CITY OF NORTH ST. PAUL PLANNING COMMISSION
REGULAR MEETING AGENDA
THURSDAY, APRIL 1ST, 2021
6:30 PM

To: Planning Commissioners

Re: Cowern Elementary School Secure Entry Addition Site Plan Review

Date: 3/26/2021
To: Planning Commissioners
From: Eric Zweber, AICP, City Planner
CC: Scott Duddeck, City Manager
Re: Conditional Use Permit and Building Height Variance Requests for North High School Addition

D1 COWERN EAST EXTERIOR ELEVATION
1/4" = 1'-0"

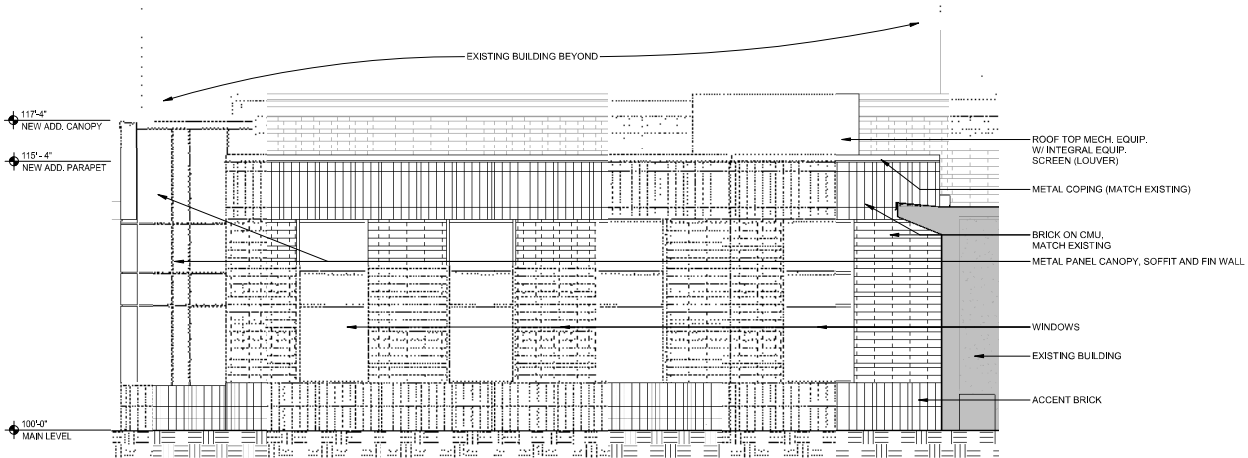
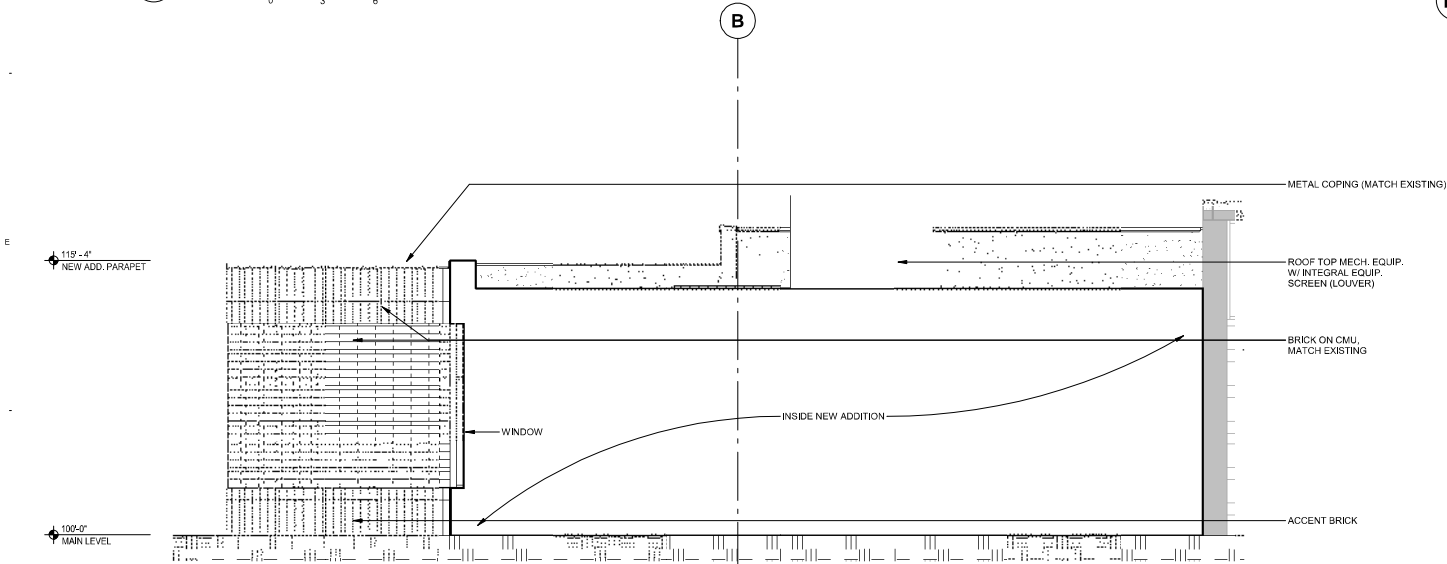
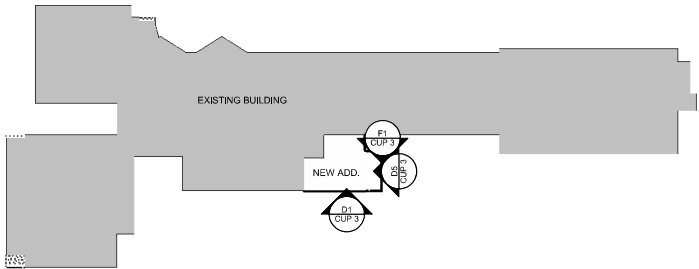
Mechanical equipment is proposed to be located on the roof top of the building addition, and the elevation plans indicate that the equipment will be screened via louver screen.

The proposed addition will be constructed with materials including brick and metal. The brick will closely match the existing building. The metal materials consist of dark bronze anodized metal panels and a metal coping. The plans show two double doors and three windows facing east, and two windows facing north. The addition will be somewhat distinguishable from the existing building, but the addition will be part of the building's entrance and it is common for an entrance to be articulated from the rest of the building. Staff finds that the proposed building materials are acceptable and that the general architectural design complies with the above noted standards.

A
C0.100
DEMOLITION PLAN
1:30

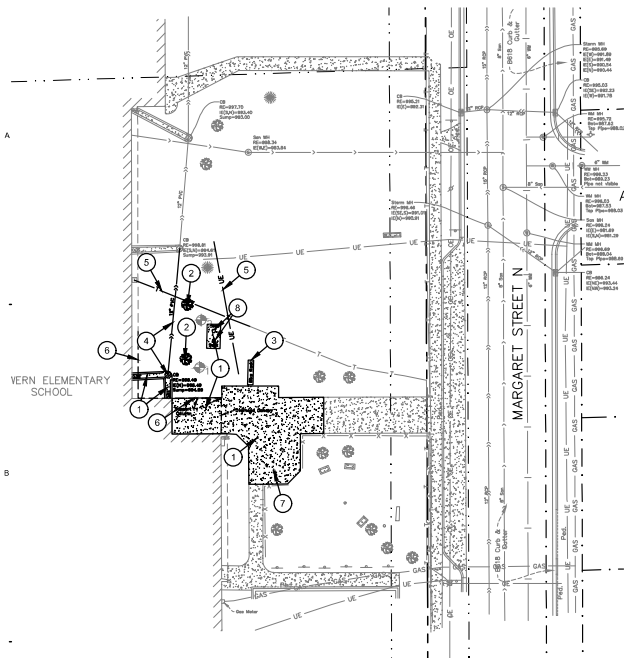
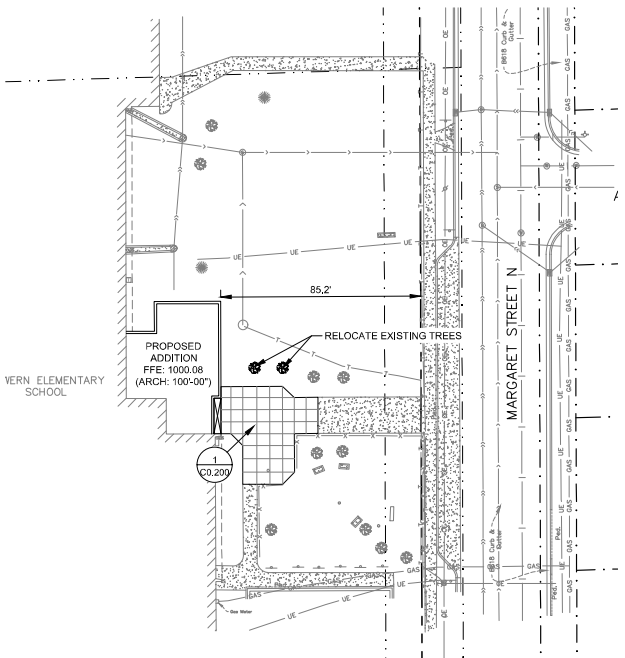
Two existing trees near the addition are proposed to be relocated. The plans do not indicate where the trees will be located. Staff finds that it would be acceptable to relocate the trees along either Margaret Street N or South Ave E.

The demolition and paving plans show that an area of the existing pavement directly in front of the current building entrance will be removed, and new concrete pavement will replace it, to connect the existing sidewalk with the proposed addition and building entrance. The width and configuration of the proposed sidewalk closely matches the current sidewalk, except the space proposed to be enclosed by the building addition.

D
C0.100
UTILITY PLAN
1:30

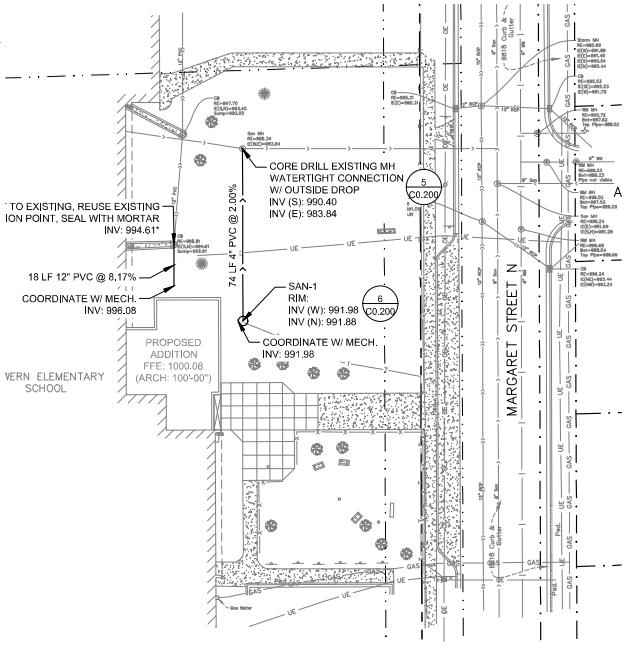
1. Additional SAC charges may be due at time of building permit based on Met Council calculations of the additional use with the expansion.
2. Show the telephone line on the Civil Site Plan as being removed further back so it does not appear as being connected to the proposed sanitary structure SAN-1.
